**Subject: Palmdale Hybrid Power Project – Docket 08-AFC-9
City of Palmdale’s Supplemental Information and Comments on the
Preliminary Staff Assessment for the Palmdale Hybrid Power Project**

**CITY OF PALMDALE'S SUPPLEMENTAL INFORMATION AND COMMENTS
ON THE PRELIMINARY STAFF ASSESSMENT FOR THE
PALMDALE HYBRID POWER PROJECT**

1:12,000

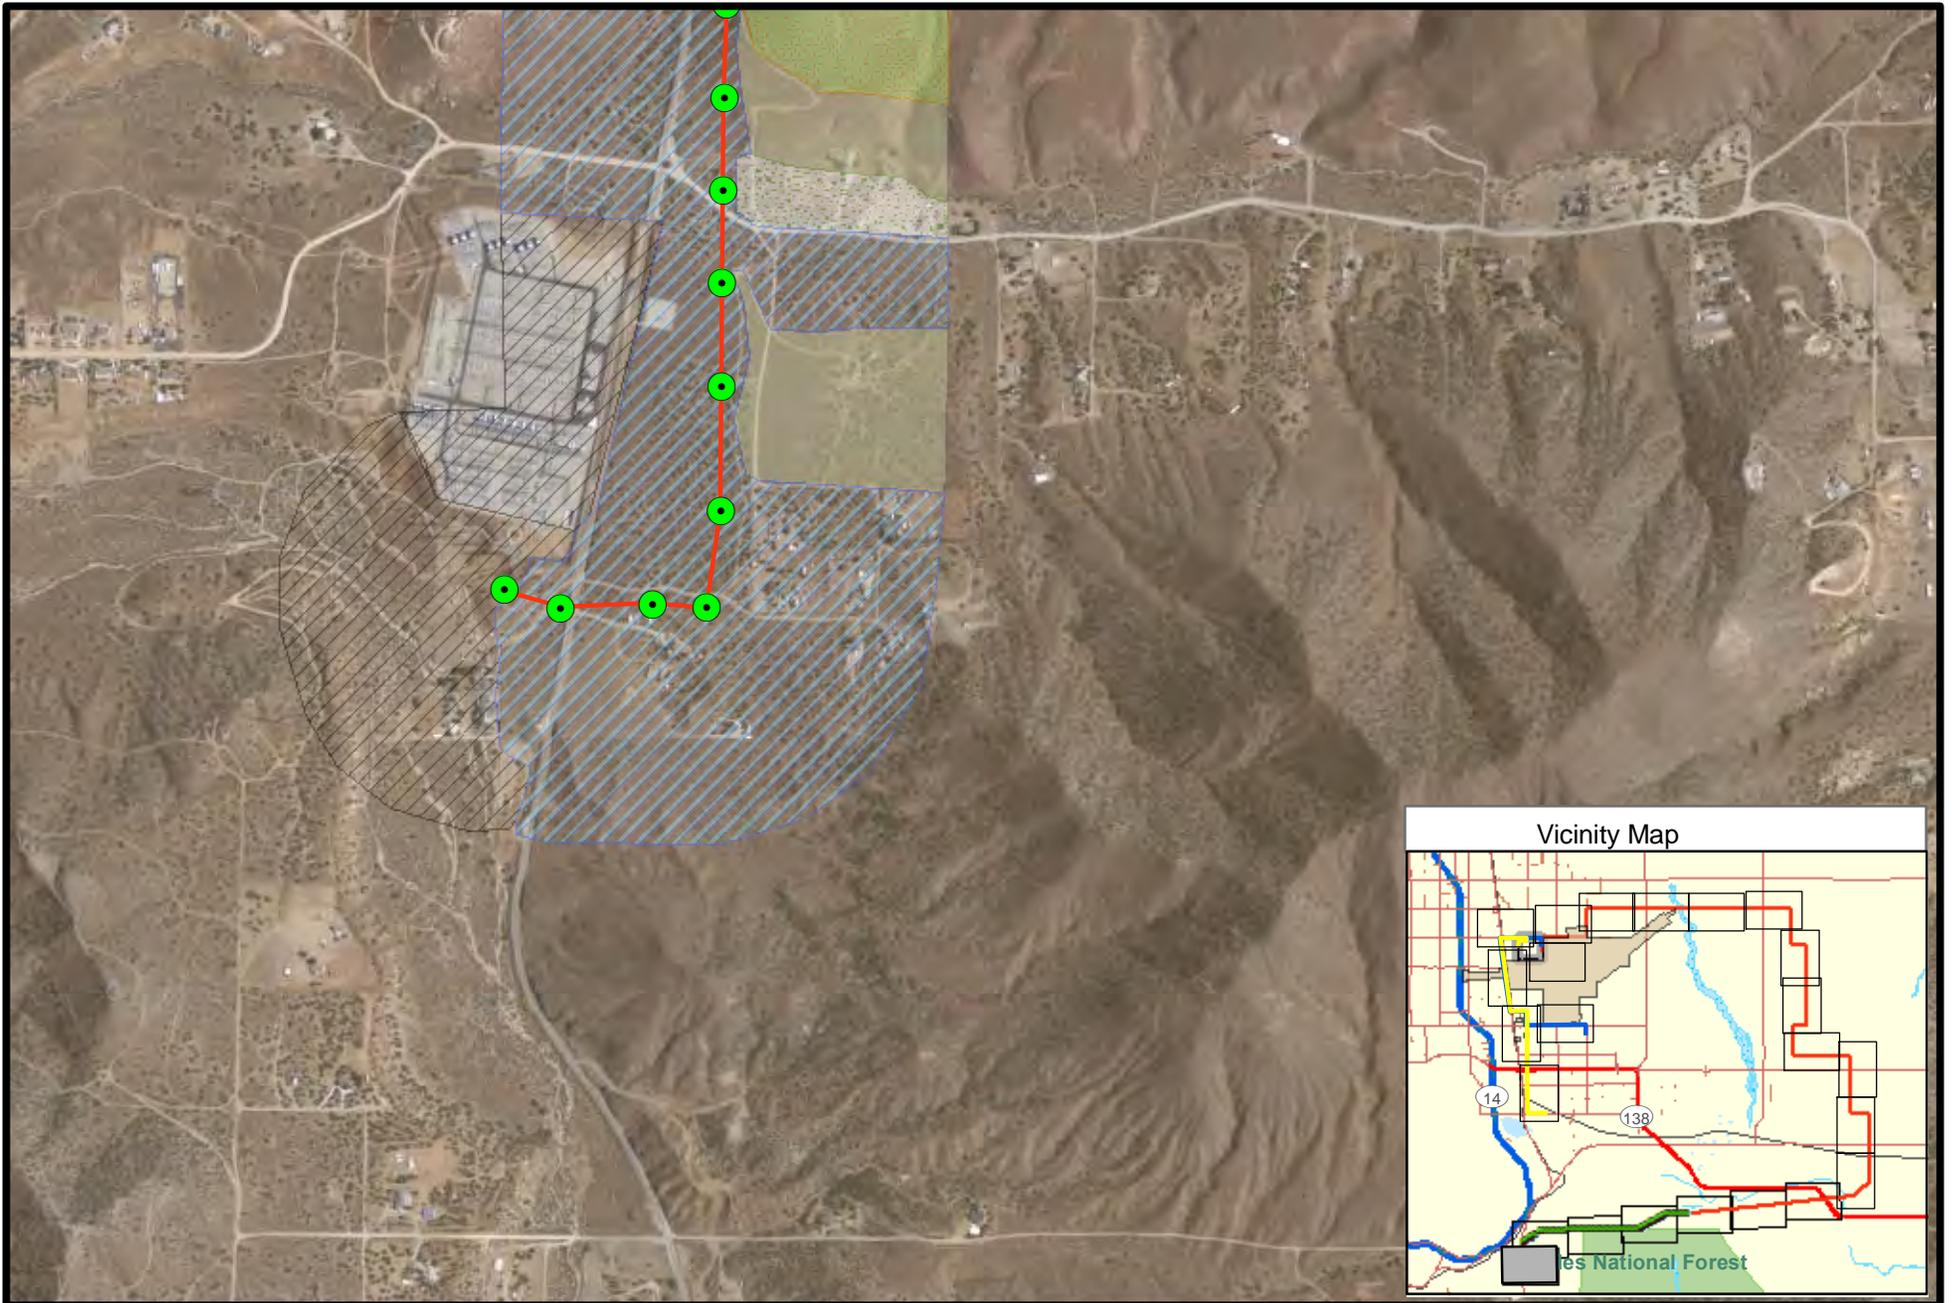
2. Revised Vegetation Mapping

One of the Applicant's consultants (AMEC Earth and Environmental) reviewed the vegetation mapping that had been provided in the AFC (Appendix H, Figure 6). Based on this review, it was concluded that no changes were needed to the vegetation mapping of the power plant site, reclaimed water pipeline or Segment 1 of the transmission line. However, some refinement of the mapping along Segment 2 of the transmission line was needed. The revised vegetation maps along this portion of the Project are provided in Attachment BR-3. The revisions to the mapping result in changes to the number of acres of the vegetative communities by the PHPP as shown in the Revised AFC Table 5.3-6R below. The changes are a combination of the new vegetation mapping as well as further refinements in project design.
